1984 - 1986 Corvette: Service Bulletin: Window Regulators - Replacement

Number: REISSUE 86-17

Subject: WINDOW REGULATORS

Model and Year: 1984-1986 CORVETTE

WINDOW REGULATOR ASSEMBLY

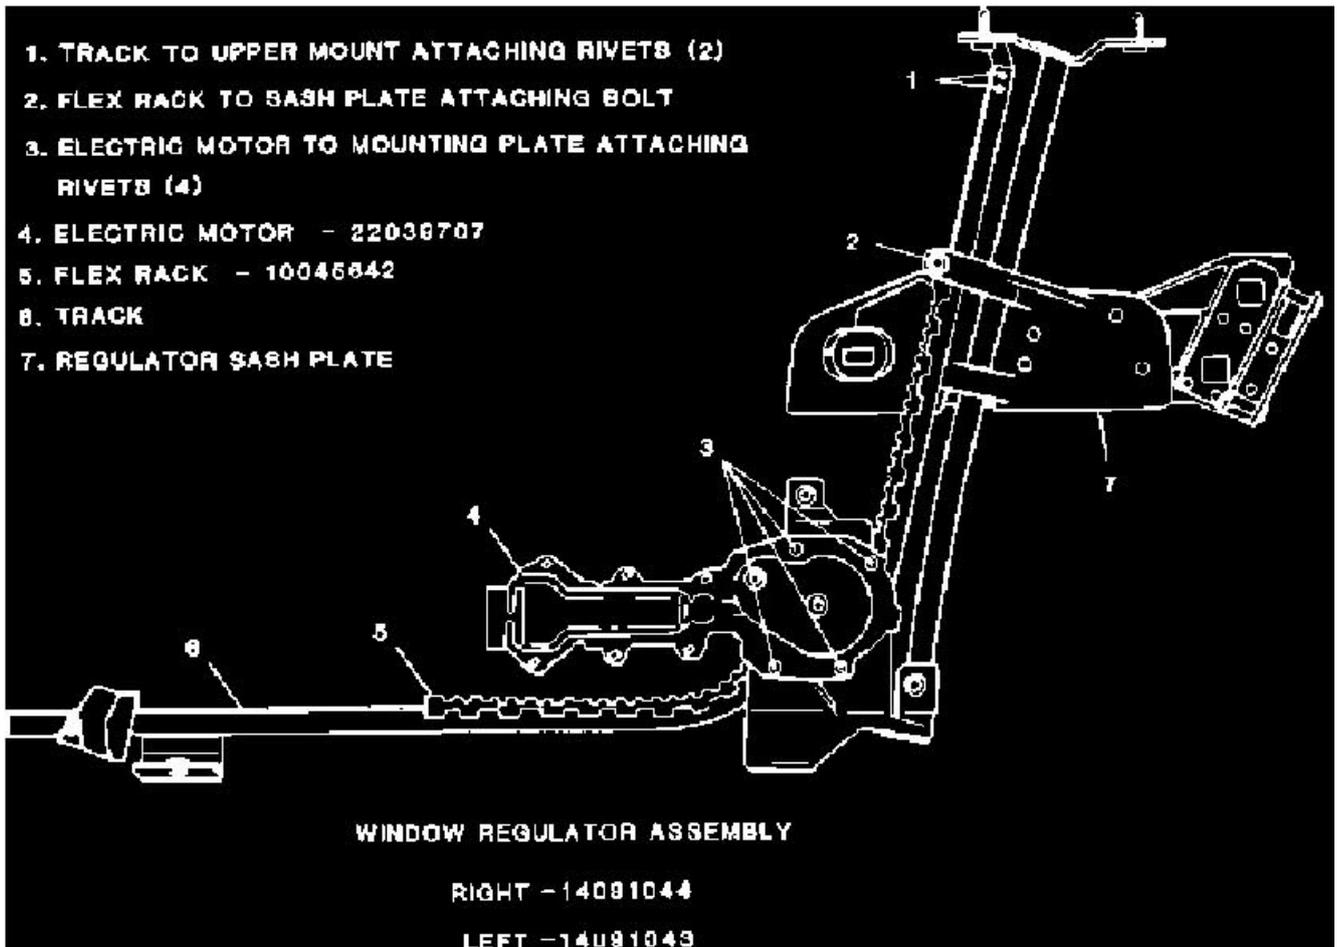
This bulletin contains part numbers and procedures for the replacement of the electric motor and plastic flex rack of the window regulator assembly (Items 4 and 5, Figure 1).

Regulator conditions encountered on vehicles built prior to September, 1984 or that have flex rack tracks which are not chrome, (Item 6, Figure 1) but are yellow or gold in color, or dull metal finish, require replacement of complete regulator assembly.

Conditions encountered on vehicles built after August, 1984 or regulators with chrome flex rack tracks (Item 6, Figure 1) may be repaired with component parts (electric motors and or revised flex racks, Items 4 and 5,

Figure 1).

1. Remove regulator assembly from door and place on a clean work surface.
2. Using an electric drill. motor and 4mm (5/32") drill bit, drill out four (4) attaching rivets that retain the electric window motor to the 1986 Chevrolet Corvette V8-350 5.7L Copyright © 2006, ALLDATA 8.80 Page 2 lower mounting place (location 3, Figure 1).

3. Remove the motor from the regulator assembly and transfer the plastic drive gear to the new motor.
4. Clean the lower mounting plate of all metal shavings prior to motor installation.

5. Apply lubricant (GM P/N 1052349 or equivalent) to the drive gear, flex rack, track and gear housing on the lower mounting plate.
6. Install the new motor to the mounting plate using four (4) 4 mm X 10 mm (5/32" X 3/8") rivets (location 3, Figure 1).

2. Using an electric drill motor and 4mm (5/32") drill bit, drill out the two (2) track to upper mounting plate attaching rivets (location 1, Figure 1).

3. Remove the Allen head type bolt (location 2, Figure 1) retaining the flex rack to the regulator sash plate. It will be necessary to hold the attachment nut on the underside of the sash plate to prevent it from rotating.

4. Lift track away from upper mounting plate and carefully pull track away from guide tube in order to disengage the flex rack and track from the sash plate opening at location 2, Figure 1.

9. Locate the flex rack and track into the sash plate opening at location 2, Figure 1. Apply Loctite Thread Sealer to the bolt threads prior to reinstalling the Allen type bolt at location 2, Figure 1 to prevent loosening from vibration.

10. Locate and fasten track to the upper mounting plate using two (2) 4mm X 10mm (5/32" X 3/8") rivets (location 1, Figure 1).
11. Using an external power source, operate the regulator to insure quiet, free operation.
